FREDERICK COUNTY PLANNING COMMISSION

TITLE: Urbana ORC MXD Retail – Lot 600

FILE NUMBER: SP-03-09 (AP#18949, APFO#18950, FRO# 18951)

STAFF REPORT

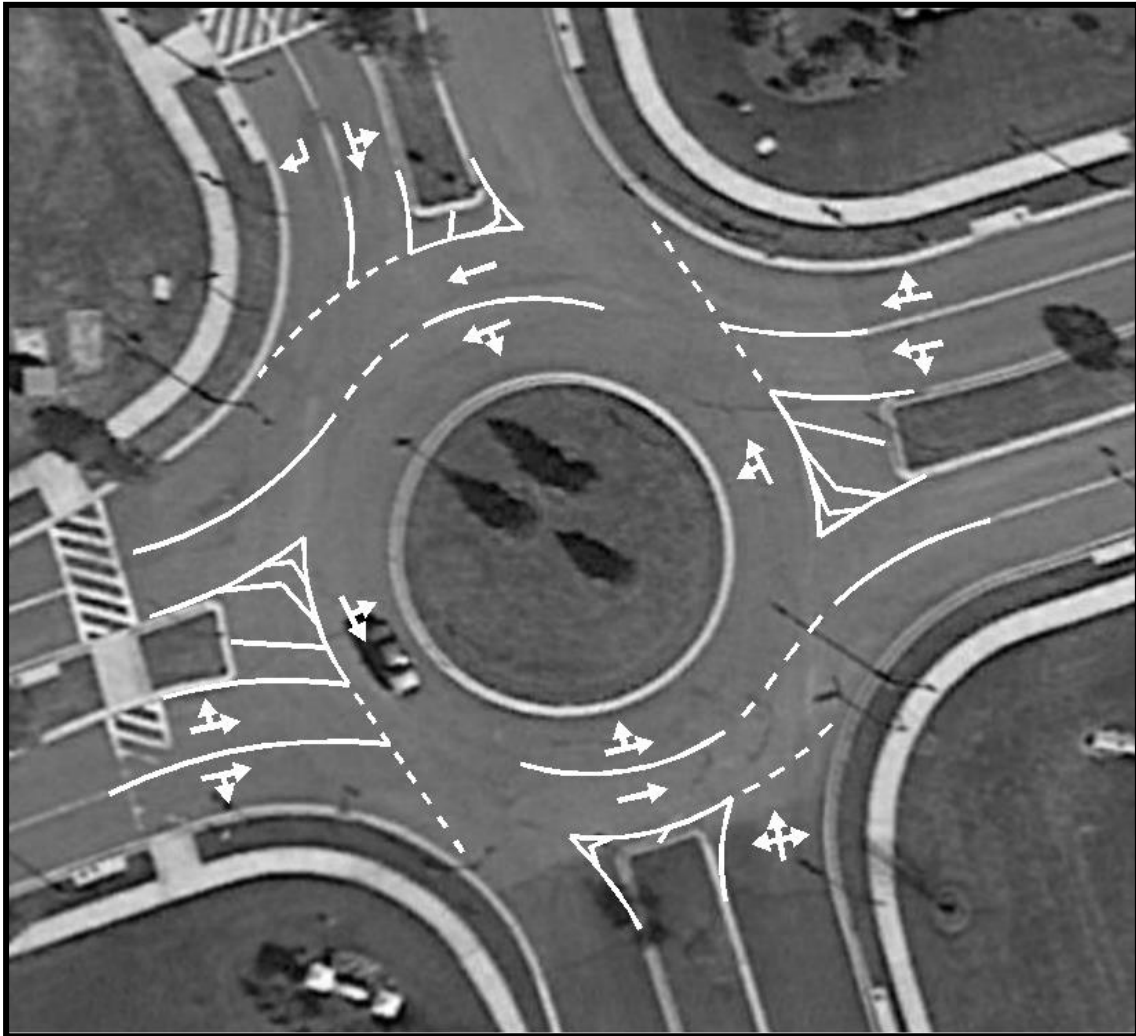
A traffic study was performed by Wells and Associates, dated January 7, 2019, that showed all

access points as currently designed operate at an acceptable level of service. The study did find that some work is required on the existing roundabout intersecting Bennett Creek Boulevard and Bennett Creek Avenue, requiring an expansion to two lanes. While the exact design will be finalized at the Improvement Plan stage, a conceptual plan is shown below.

1. The Applicant shall comply with all Staff and agency comments through the completion of the plan.
2. The Applicant shall, as part of the project's frontage improvements, improve the existing roundabout to a two-lane roundabout - largely through pavement striping and nominal physical improvements - to assure safe deflection angles and adequate diameter.
